Pentium® II Processor Specification Update

Release Date: May 1999

Order Number: 243337-026

Figure 1. UP Dual Ended Termination (DET)

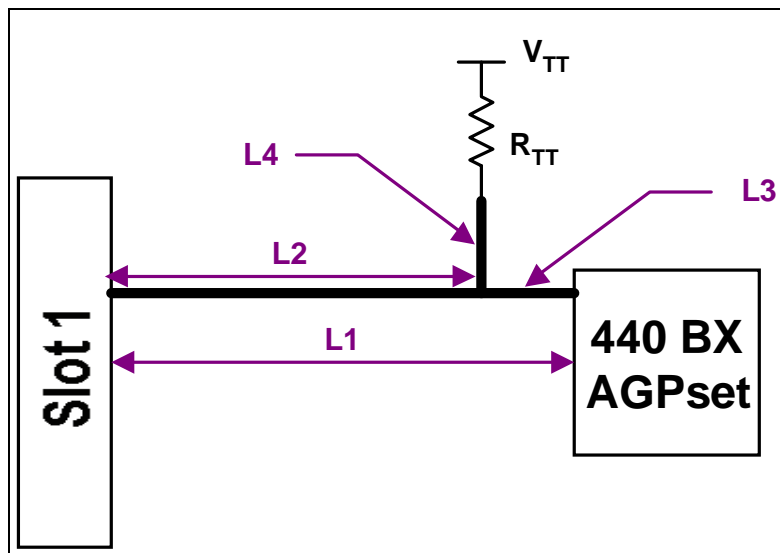
For UP-DET topologies (see Figure 1), the trace length L1 must be between 1.5" to 4.5" while using a 56Ω termination resistor.

WORKAROUND: If the chipset and third party agents used with the Pentium II processor do not optimize their arbitration latency as described above, no action is required. For the 66 MHz Pentium II processor, no action is required. If agents that have implemented this optimization, by following the *100 MHz GTL+ Layout Guidelines for the Pentium® II Processor* and *Intel 440BX AGPset* for UP-SET (single-ended termination) and DP with both processors installed, no action is required. The following two cases are additional guidelines for UP-DET (dual-ended termination) and DP-DET with only one processor populated.

Figure 2. DP Dual Ended Termination (DET)

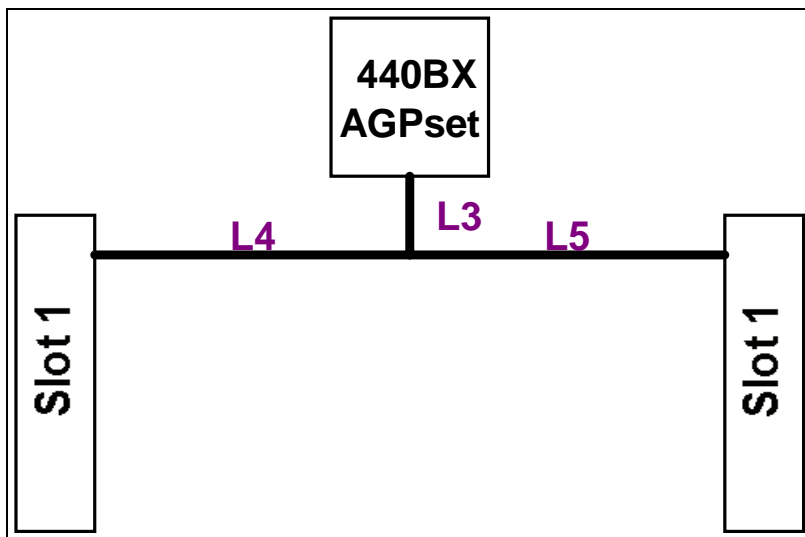
For DP topologies (see Figure 2) installed with a processor and a termination card, $L4 + L3$ or $L5 + L3$ must be less than or equal to 4.5". Additionally, for DP platforms with one processor installed, the termination card should be placed in the longer leg.
